Access Compliance Report

Public Rights-of-Way

Intersection ID: 26425	Main Street: BEVINGTON_PL	Cross Street: BIRKDALE_VALLEY_DR	Location: E
ADA ID: 24C9A847DFF8	Ramp Type: BlendTrans2	Initial Pass/Fail: Pass	Overall Compliance: No
		Severity Score: 2.75

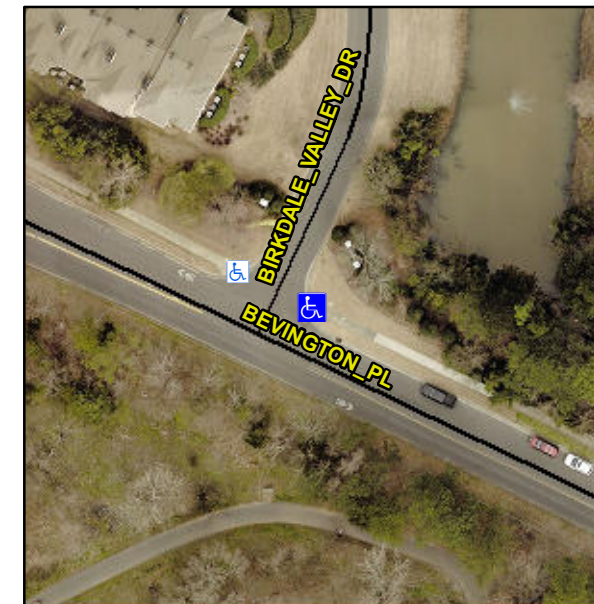
Not Found, R304.5.3, R305.1.4, R305.2

Compliance	Description	Data	Compliance	Description	Data
N/A	Ramp Length (in)	71.0	Yes	BlendTrans Slope (%)	2.2
Yes	Ramp Width (in)	48.0	No	BlendTrans XSlope (%)	4.8
N/A	Flare Type LT	Sloped	N/A	Flare Type RT	Sloped
N/A	Flare Slope LT (%)	N/A	N/A	Flare Slope RT (%)	N/A
N/A	Flare Traversable LT?	No	N/A	Flare Traversable RT?	No
N/A	Landing Length (in)	N/A	Yes	DWS Provided?	Yes
N/A	Landing Width (in)	N/A	Yes	DWS Contrast?	Yes
N/A	Landing Slope (%)	N/A	Yes	DWS Length (in)	25.5
N/A	Landing X Slope (%)	N/A	No	DWS Full Width?	No
N/A	Landing Curb? (Y/N)	No	No	DWS Offset (in)	2.5
N/A	Shared Landing?	No			
Yes	Gutter Ponding?	No	Yes	Gutter Slope (%)	2.9
Yes	Gutter Lip Ht (in)	0.0	No	Gutter X Slope (%)	4.3
N/A	Painted X Walk1?	No	N/A	Painted X Walk2?	No
	X Walk 1 Direction	To NW		X Walk 2 Direction	To SW
	X Walk 1 Width (in)	N/A		X Walk 2 Width (in)	N/A
	X Walk 1 Slope (%)	5.0		X Walk 2 Slope (%)	0.3
	X Walk 1 X Slope (%)	0.3		X Walk 2 X Slope (%)	5.6

N/A	Ramp inside XWalk1?	N/A	N/A	Ramp inside XWalk2?	N/A
	Road Slope (%)	3.3		Clear Space?	Yes
	Road X Slope (%)	5.0	N/A	Clear Space to XWalk (in)	N/A
Yes	Any Obstructions?	No	Yes	Storm Grate/Utility Hazard?	No
	Obstruction Type			Storm Grate/Utility Type	
		N/A			N/A
			Yes	Surface Condition? (G/P)	Good
			No	Curb Slope (%)	10.5

Remove & Replace Curb Ramp With Two New Directional Ramps or Equivalent. Remove & Replace Gutter.
